# LIGHTING ASSESSMENT ADDENDUM

PROJECT: MEMORIAL PARK, SONNING COMMON

PROJECT NUMBER: 1716			DOCUMENT REF: 1716-DFL-ELG-XX-RP-EO-13001			
S3	P03	Fourth Issue	TP	RC	RC	17/08/2021
S3	P03	Third Issue	TP	RC	RC	21/06/2021
S3	P02	Second Issue	TP	RC	RC	11/06/2021
S3	P01	First Issue	TP	RC	RC	02/06/2021
Suitability	Revision	Purpose Description	Originated	Checked	Approved	Date

Figure 1 – MUGA Lighting Zone Division

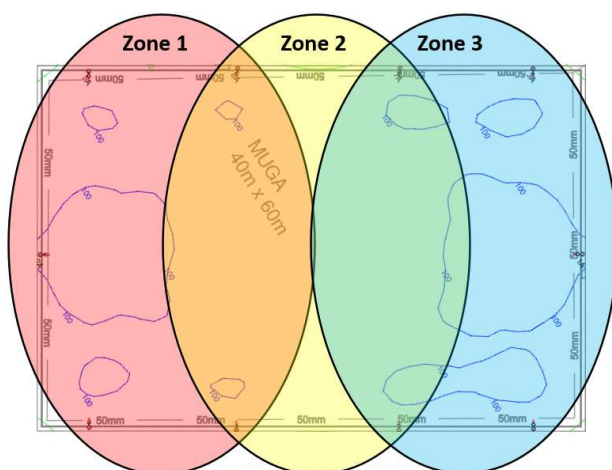
- 1.3.11 Lighting is now to be subject to a more stringent 21:30 hours curfew, after which all lighting will be switched off.
- 1.3.12 The on-demand button to switch lighting is to be located within the MUGA fence to enable easy access for users of the Proposed Development.
- 1.3.13 This approach ensures that the MUGA is lit to the lowest possible level, and is only illuminated when in use.

Figure 1.1 – Indicative Column design (As per DW Windsor Conical)

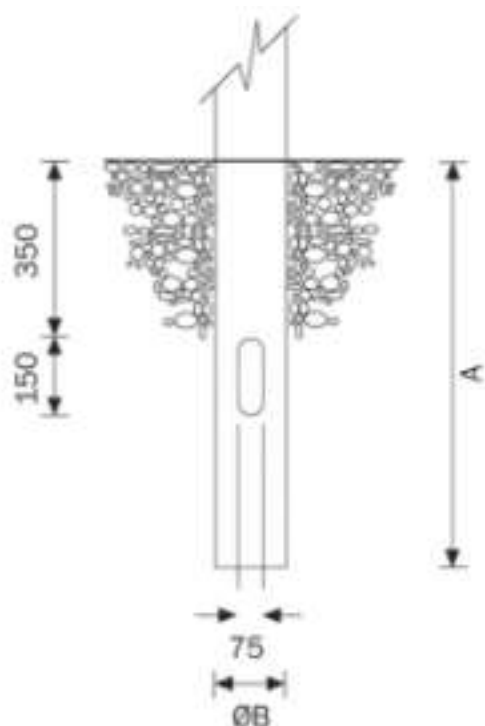
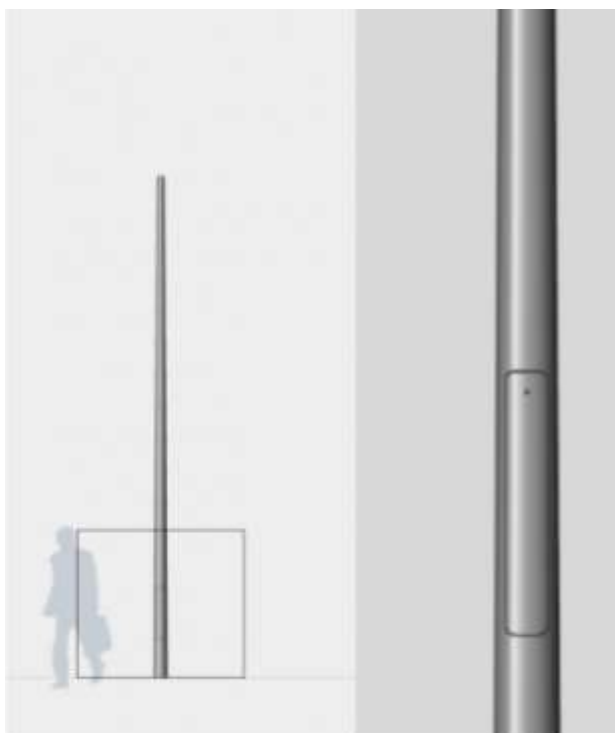
- 1.3.2 Lighting for the proposed MUGA is to be mounted to 8m columns, however, these columns are to be suitable to the character of the Application Site. This is to be achieved through the use of decorative “street” style columns, in place of galvanised floodlighting columns, which are to be finished in a colour in keeping with the character of the area (eg. RAL 6013 Reed Green).
- 1.3.3 When specifying columns for the illumination of the walking/running/learn to cycle track, the finishing colour of these columns would match that used for the MUGA facilities.
- 1.3.4 Drawings and visualisations of indicative column designs and finishes are presented in **Appendix 1**.
